File Number: 8-A-25-IH

**Meeting:** 9/17/2025  
**Applicant:** Tony Nelson Master Plan Builders and Design  
**Owner:** Gregory and Wilhelmenia Yarborough  
**District:** Lonsdale Infill Housing Overlay District

**Location:** 3305 Savoy St. **Parcel ID:** 81 P A 012  
**Zoning:** RN-2 (Single-Family Residential Neighborhood)  
**Description:**  
New primary structure.

Level III Subdivision/Plat, New Primary Structure

FRONT ELEVATION  
SCALE: 1/4" = 1'-0"

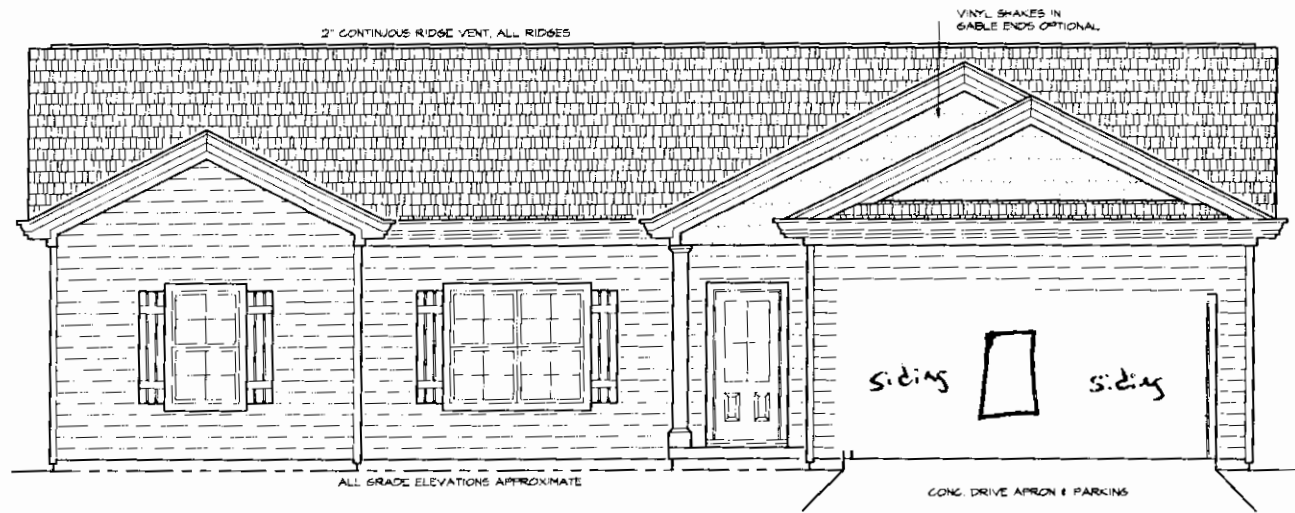
6. The four-bay, one-story façade is similar in height to the context, but it is wider in scale.

7. The design features a 6' wide by 8' deep stoop recessed under the telescoped front-gable massing and supported by one 8" square column. The guidelines recommend that new construction feature porches with proportions and supports similar to the context, allowing for stoops where porches are not traditional. The infill construction present on the block and surrounding area features partial-width porches. The Board should discuss whether the proposed stoop should be widened.

solid to void. The proposed half-lite paneled front door is appropriate. The 4/4 single-hung and 1/1 single-hung windows are compatible with the context, and the façade, right, and rear elevation feature a sufficient ratio of solid to void. A window should be added to the left elevation to avoid a blank wall. The façade elevation drawing should be formally revised to show the proposed window in the right bay, which should feature the same design as the adjacent windows.
